Response to Reviewer 1:

Summary response and major concerns by the reviewer 1:

Incubation 1 for the control and treatment conditions.

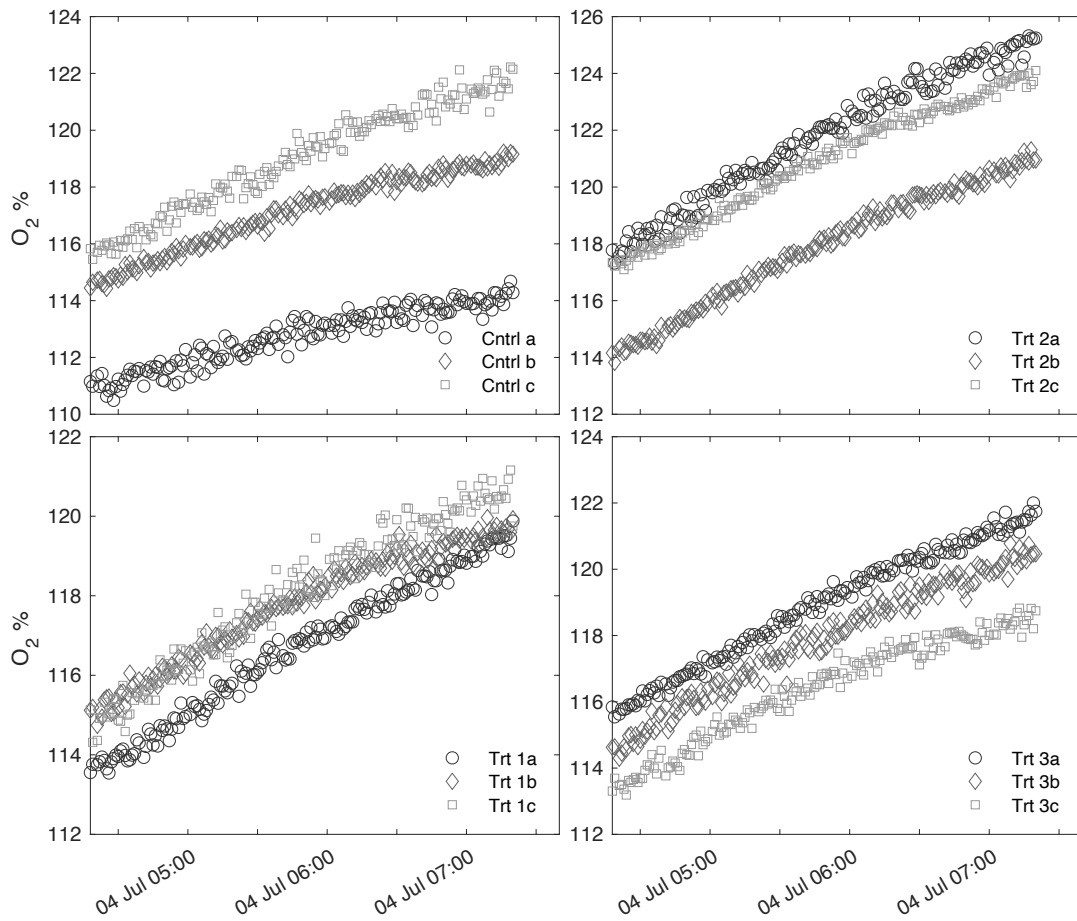
L110-112 “The response of communities...”: I understand that you want to publish your data in a separate paper. However, when you want to publish a technical note on your system, you need to show that your system works and that the treatment has an effect on the biology. Hence, I expect that you show at least some biological results of a pre-experiment or similar... Otherwise, I suggest to use the here presented data in the (extended) method section of the other manuscript - and not as a stand-alone paper. **We understand the concern of the reviewer to show the biological response of the organism(s) exposed to the treatments as a proof of application, however, we respectfully disagree that showing biological data is a standard procedure when describing an experimental system (e.g., Jokiel et al. 2014; Olariaga et al. 2014). We especially believe we can prove that an experimental system can work even if the simulated treatments do not have an effect on biology. The guidelines of a Technical Note also do not mention this within the scope of the journal. We feel that we have appropriately shown that the system can modify and regulate the salinity and temperature as described in the manuscript. To alleviate any concern about being able to stimulate a biological result, we point the reviewer to our response above which includes a plot of oxygen evolution during one of the incubations. We can also provide an update to this interactive discussion once the partner manuscript is published as a preprint.**

assure lucidity throughout. We respectfully disagree with the reviewer that there needs to be evidence of a biological effect. As per suggestion by reviewer # 2, we have chosen to remove details about the biological component and focus more on the system itself. We agree with this suggestion as the aim of the manuscript is to show the functionality and assess the potential to manipulate environmental parameters, not to assess a biological response. We have, however, provided a figure below showing the continuous measurement of oxygen during an incubation to provide a visual of the biologically induced response. For further evidence of the experimental results that utilized this system we will provide reference to Miller et al. (community level effects) and Lebrun et al. (organismal level effects) as soon as the preprints are available. We will update this interactive discussion with the link to the preprint as soon as possible.
